**ITEM 1.3(d)**

**Issue/ Objection:**Natural Ventilation

85 Harrington Street
The Rocks
GOLDEN AGE & HANNAS THE ROCKS

RESPONSE TO DoPE ITEM 1.3(d)

Figure 6 - Flow pattern around a single-sided apartment with articulated façade

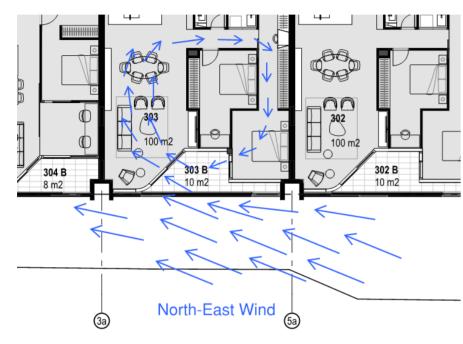
The proposal includes the five single aspect maisonette units as achieving natural cross ventilation. Further evidence is required demonstrating how these units achieve natural cross ventilation. Consideration should also be given to alternative dieting solutions for non-cross ventilated units to improve natural ventilation.

29 Apartments achieve compliance as per the apartment design guide's (ADG) definition of natural cross ventilation. 5 Apartments achieve cross ventilation as detailed in qualitative assessments undertaken by ARUP. Refer to all additional information prepared by ARUP.

Table 1 provides a summary of the number of apartments for each level that would be considered naturally cross ventilated under the ADG design criteria. There are a total of 56 apartments. Under the ADG, 34 of the 56 apartments would be required to be naturally cross ventilated to meet the design criteria. The current design has 29 naturally cross ventilated apartments. However, it is Arup's opinion that at least 43 apartments would be expected to achieve sufficient natural ventilation to meet the qualitative requirements of the ADG.
